## PIC18F44/45/54/55Q71 Silicon Errata and Data Sheet Clarifications

The PIC18F44/45/54/55Q71 devices that you have received conform functionally to the current device data sheet (DS40002350C), except for the anomalies described in this document.

The silicon issues discussed in the following pages are for silicon revisions with the Device and Revision IDs listed in the table below.

### 1.4.1 UART TXDE Signal May go Low Before The STOP Bit Has Been Entirely Transmitted.

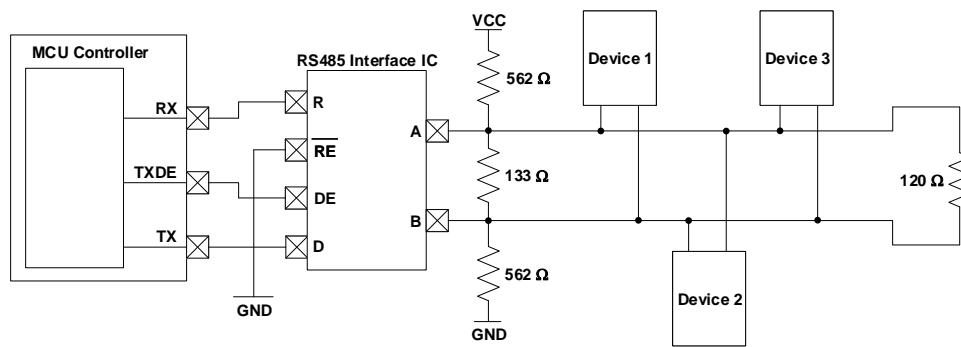
The UART Transmit Drive Enable (TXDE) signal could potentially transition into a low state before the UART STOP bit has been entirely transmitted due to the effects of parasitic capacitance on the TX line. In some applications, this could result in communication being prematurely terminated due to the TXDE bit going low before the STOP bit has had enough time to settle.

In order to ensure that the STOP bit settles into its final logic state before the TXDE signal transitions low, a biasing circuit can be implemented. A biasing circuit allows the TX line to either be driven high or low, rather than being left in a floating tri-state mode where prolonged rise or fall times could lead to communication being disrupted. This bias circuit should only be implemented on one end of the serial bus, and a termination resistor should be used on the other end. The figure below show an example of a bias circuit that can be used to achieve this.

Please note that the resistor values used in this circuit are recommendations, and that the actual resistor values required may vary based on the application.
